ONE SYDNEY HARBOUR

BARANGAROO SOUTH

STAGE 1B - Building R4B

SECTION 4.55

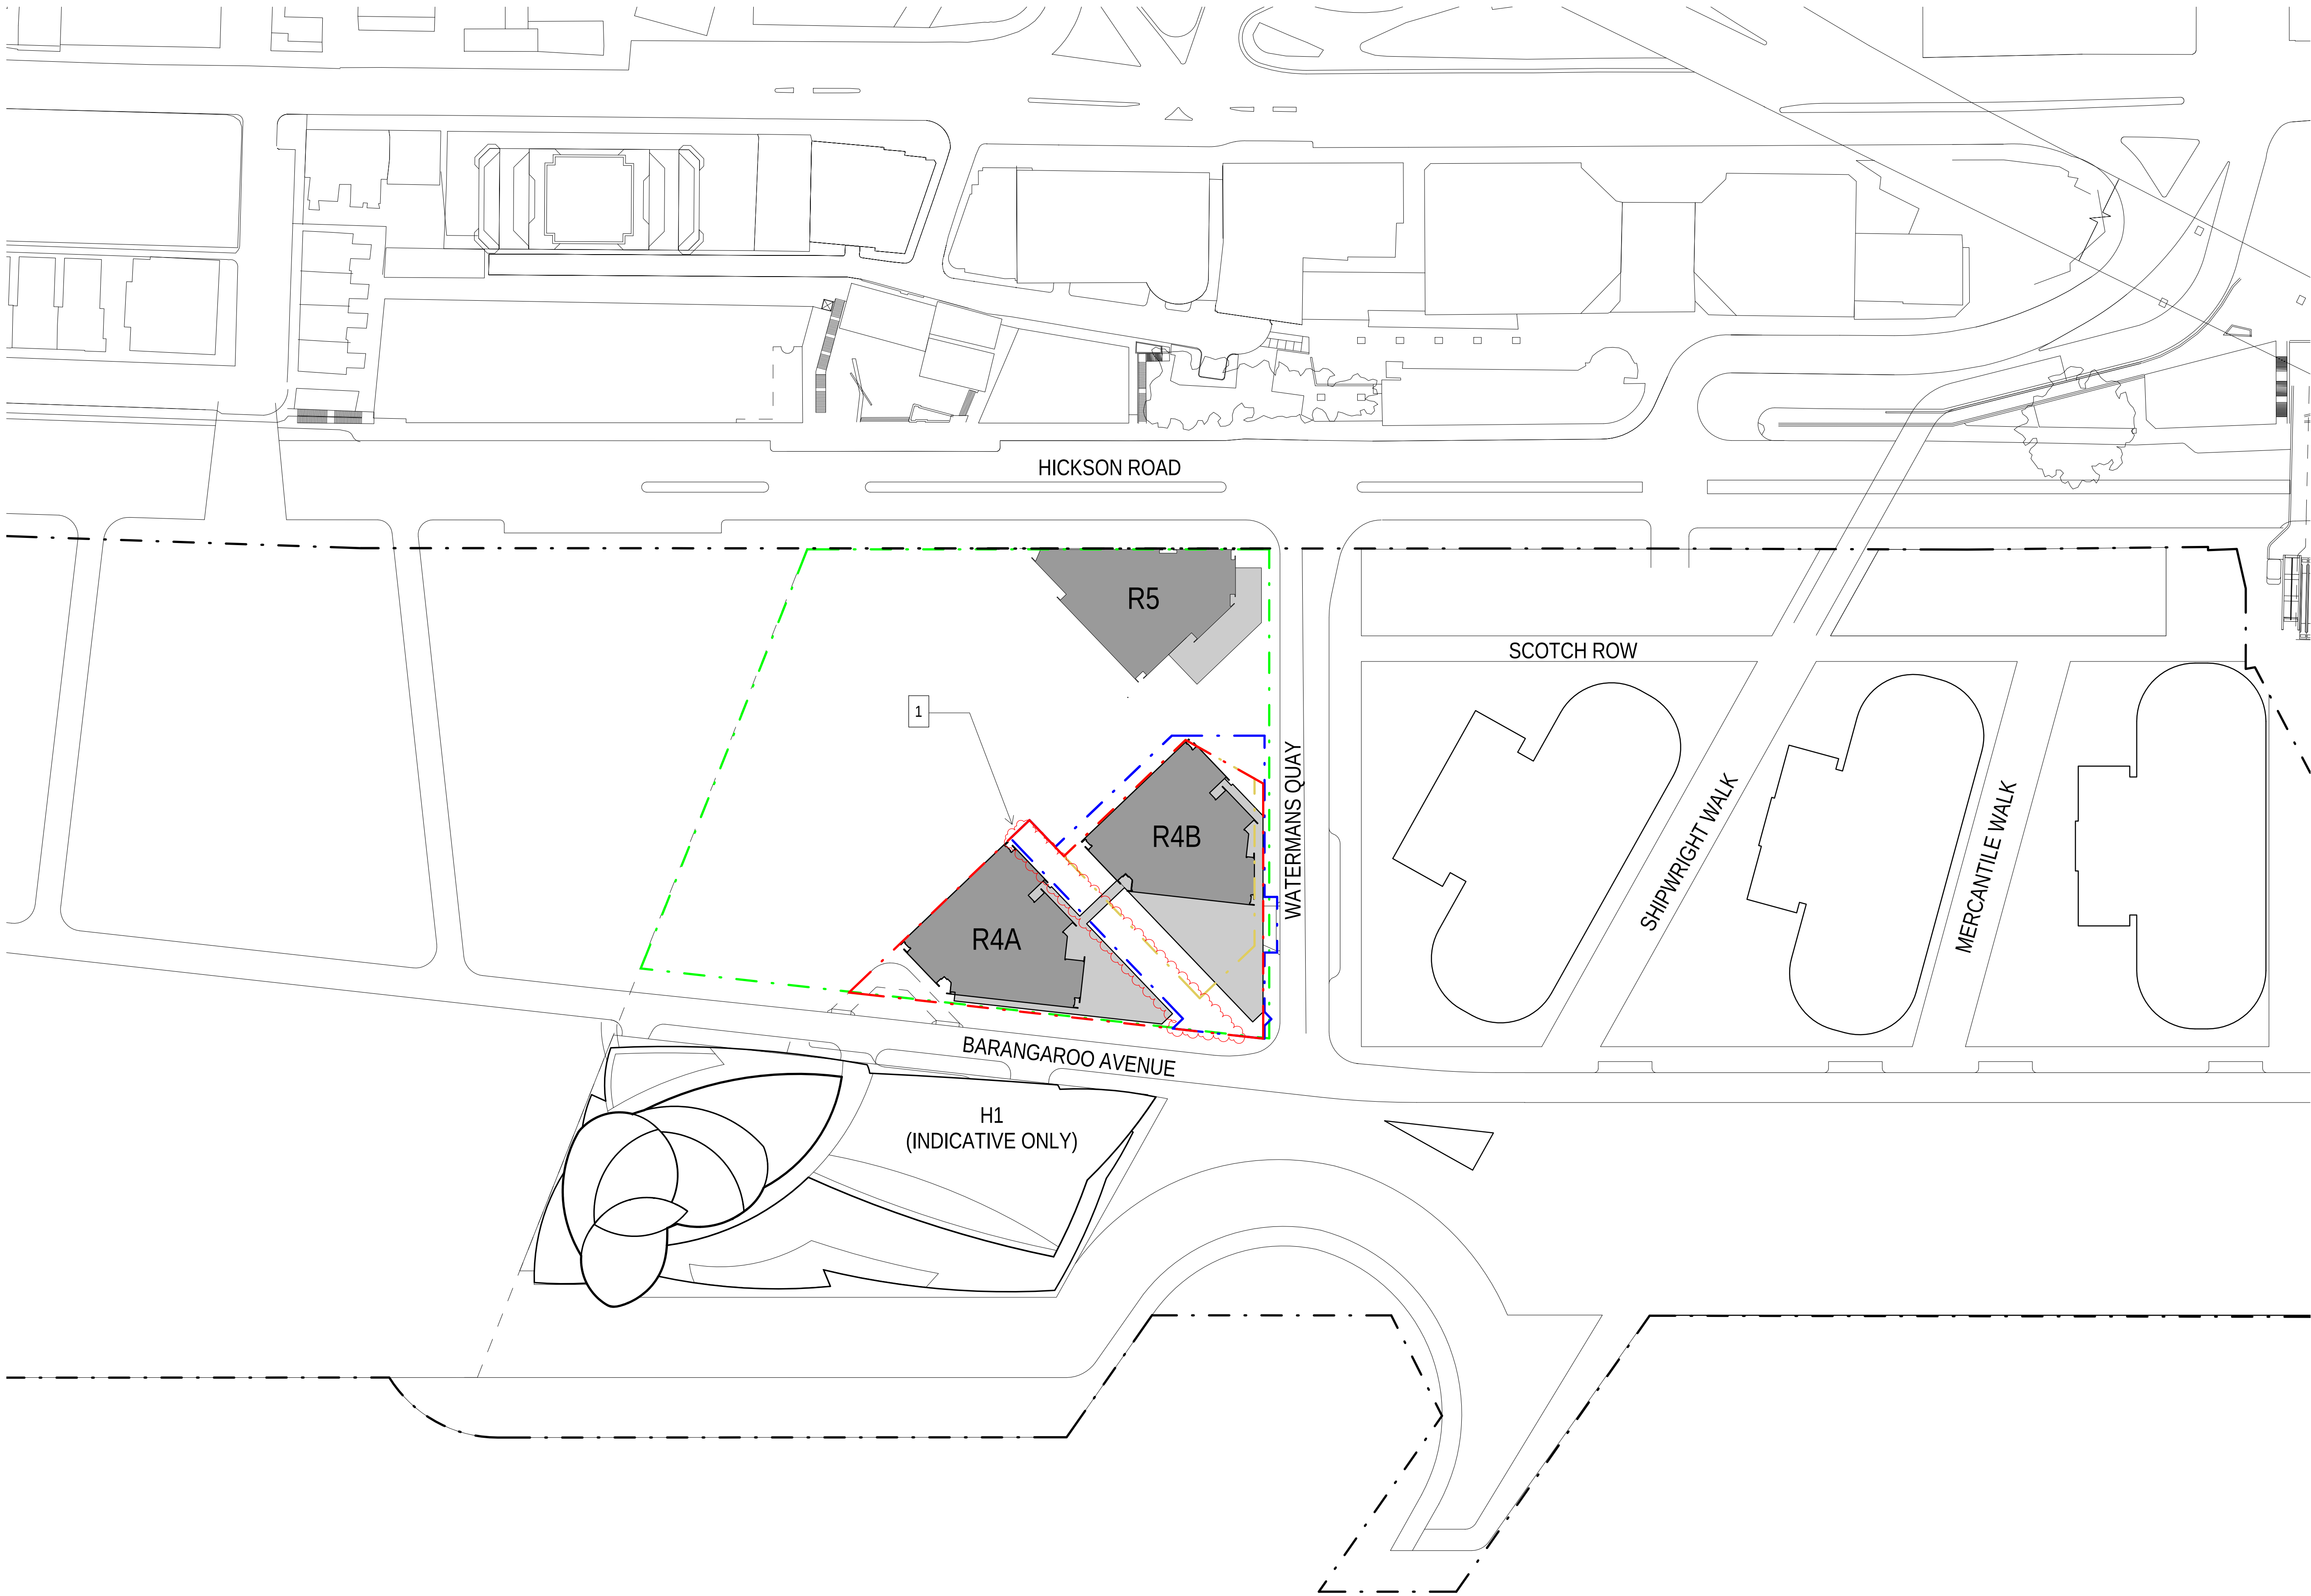
MODIFICATION:

1. DEVELOPMENT APPLICATION BOUNDARY CHANGED.

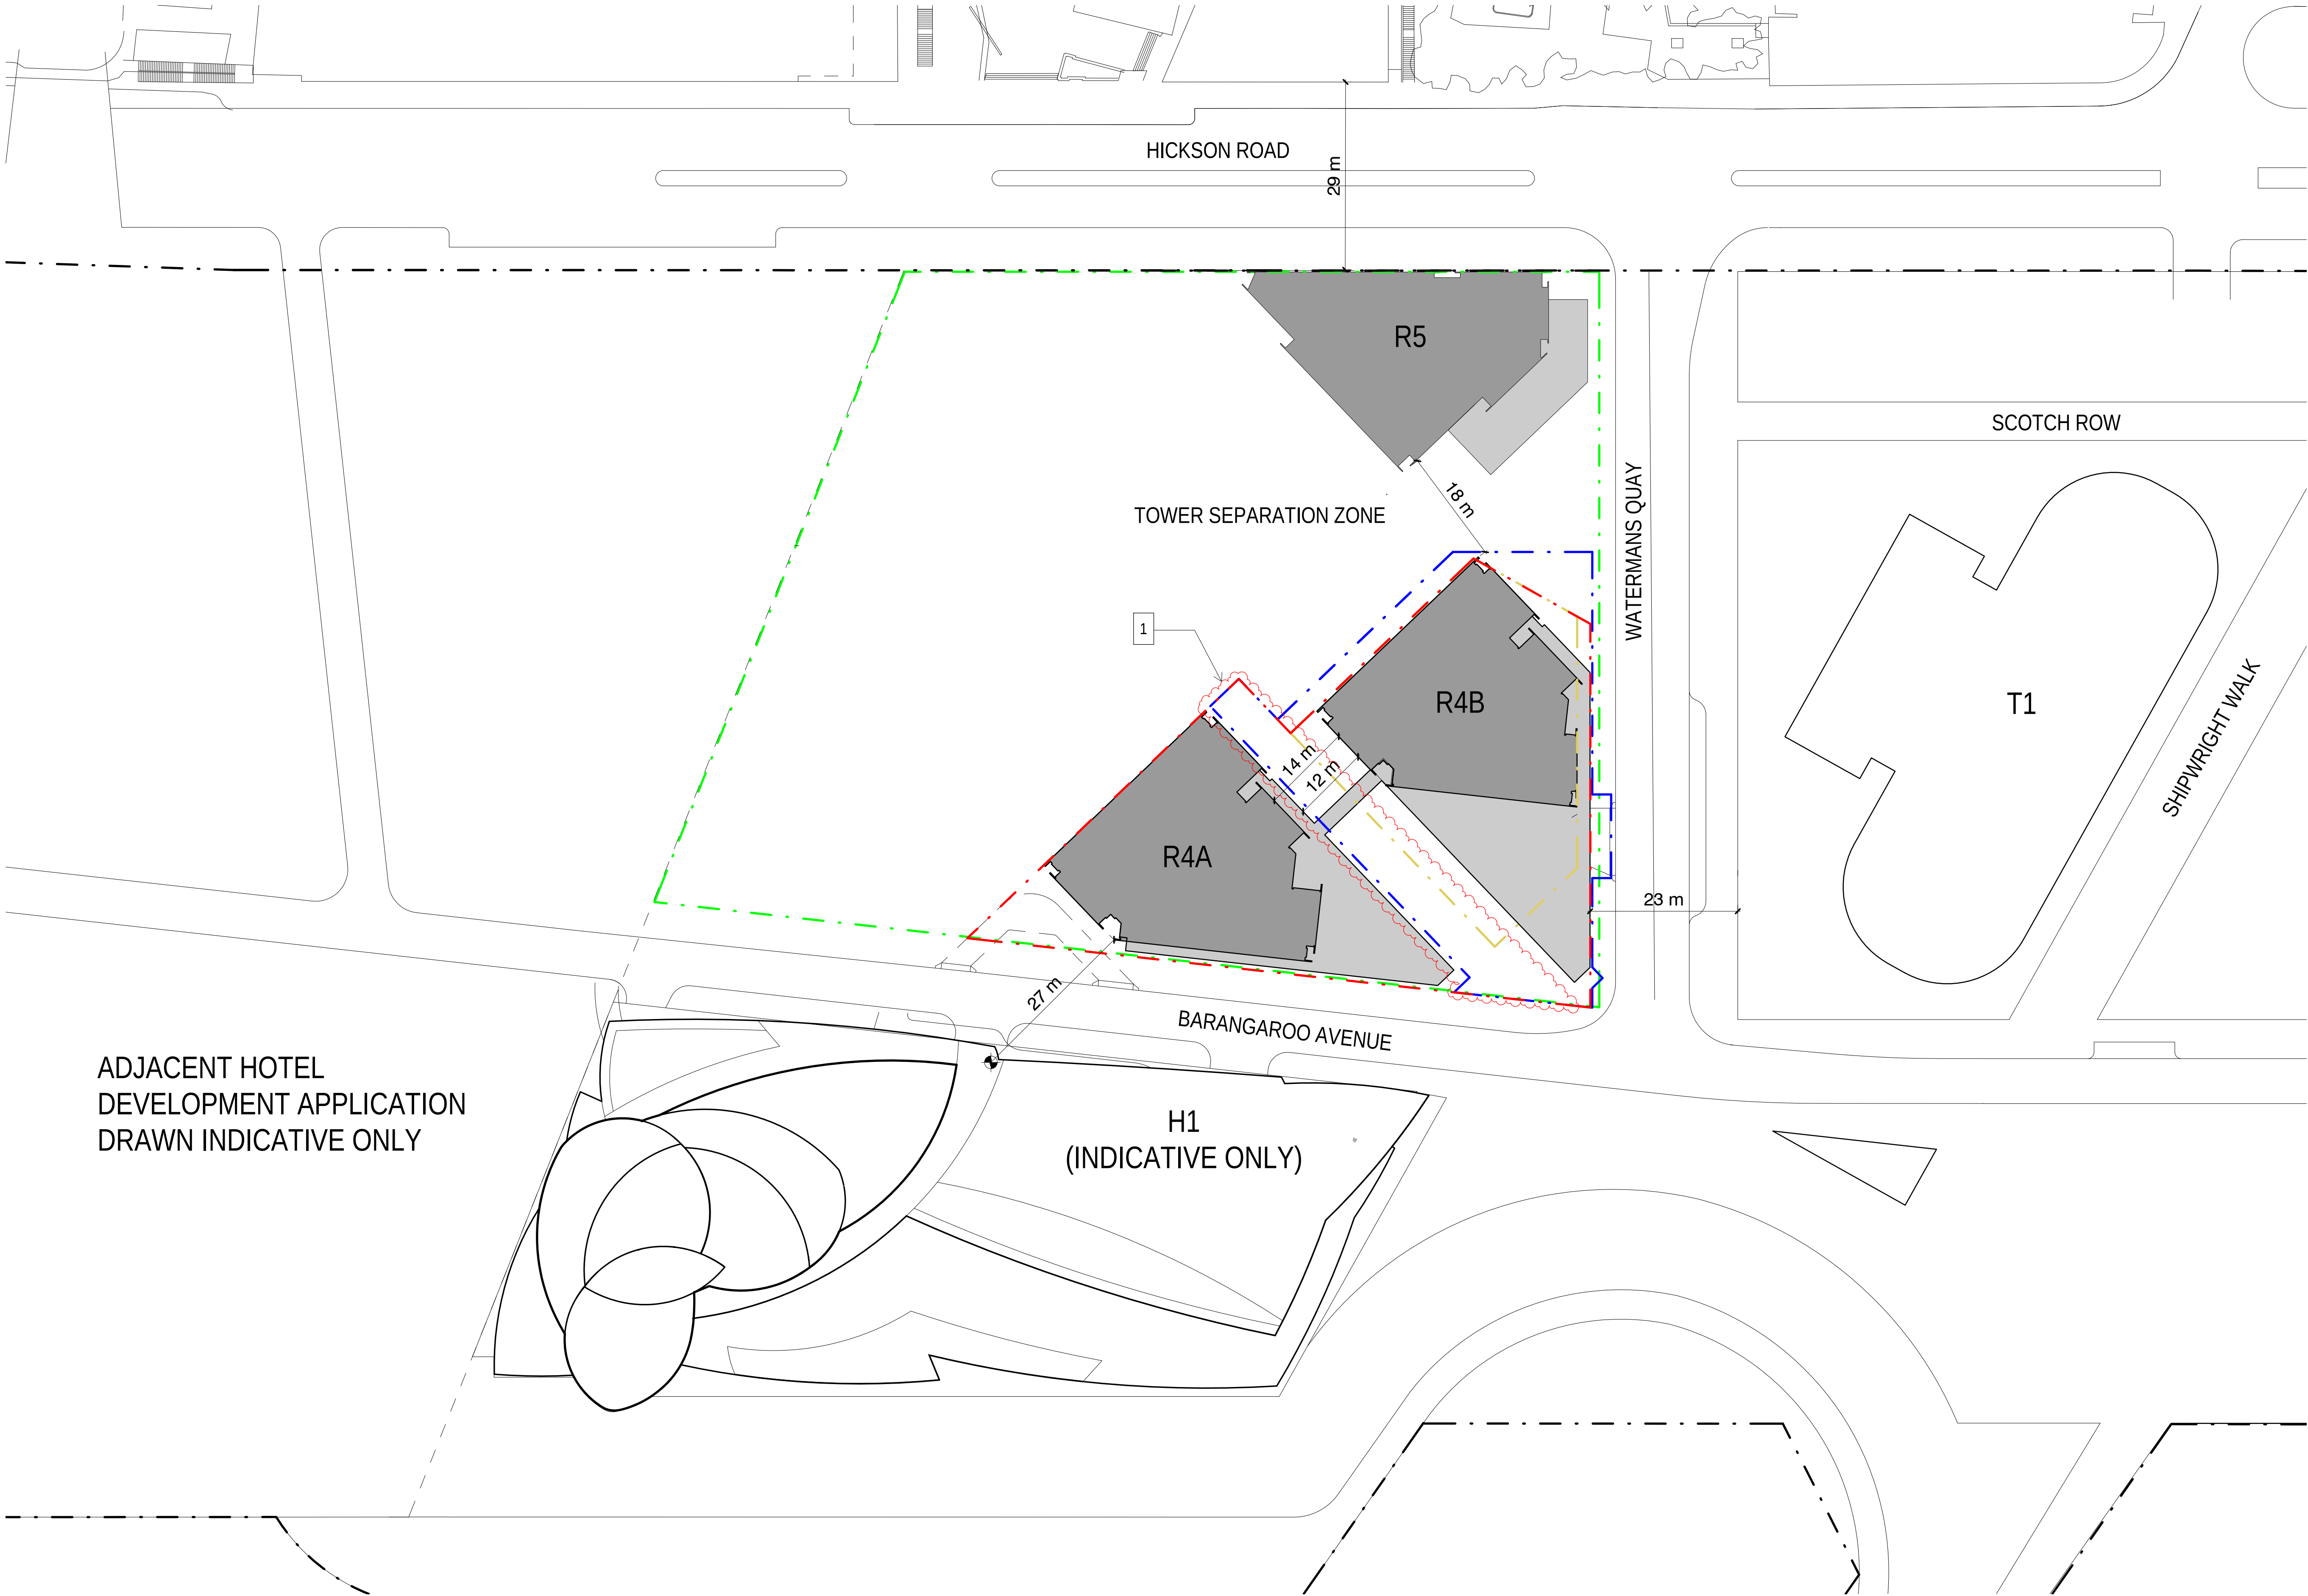
1. DEVELOPMENT APPLICATION BOUNDARY CHANGED.
2. VESTIBULE AMENDED.
3. DOUBLE DOOR SECONDARY LOBBY EXIT ADDED.

LEVEL	RL
Ground Floor	3.500

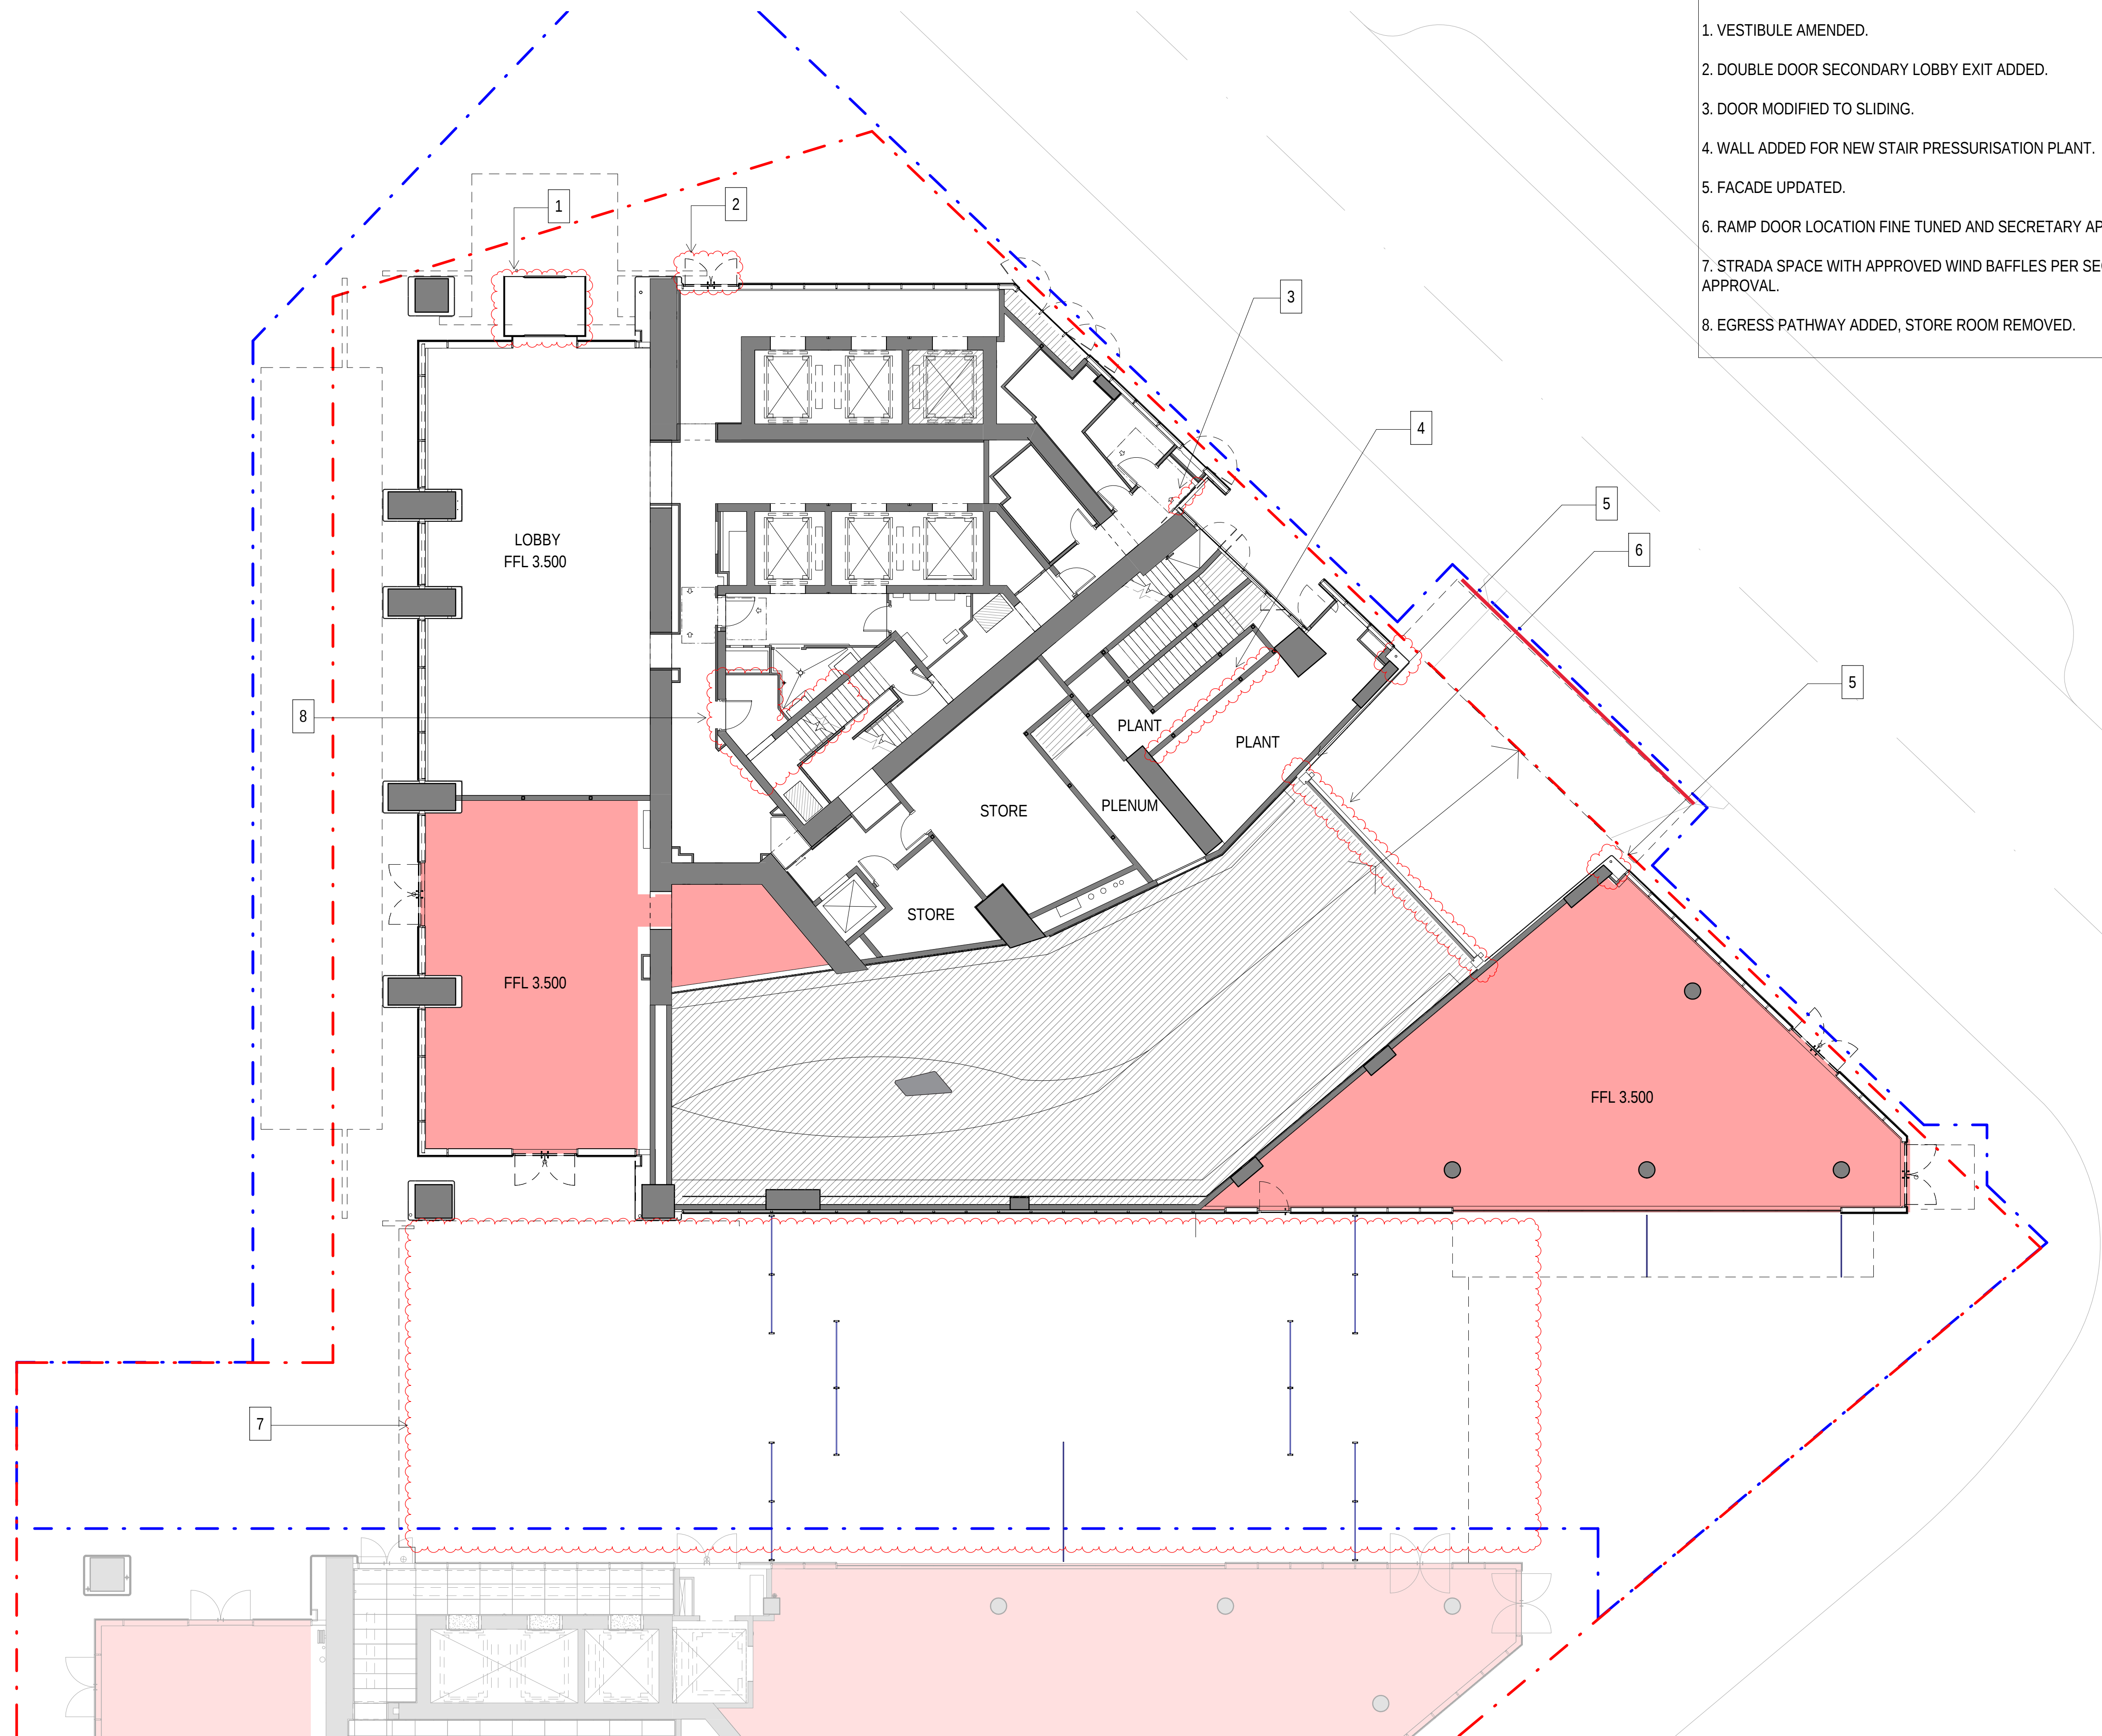
- MODIFICATION:**
1. VESTIBULE AMENDED.
 2. DOUBLE DOOR SECONDARY LOBBY EXIT ADDED.
 3. DOOR MODIFIED TO SLIDING.
 4. WALL ADDED FOR NEW STAIR PRESSURISATION PLANT.
 5. FACADE UPDATED.
 6. RAMP DOOR LOCATION FINE TUNED AND SECRETARY APPROVAL.
 7. STRADA SPACE WITH APPROVED WIND BAFFLES PER SECRETARY APPROVAL.
 8. EGRESS PATHWAY ADDED, STORE ROOM REMOVED.
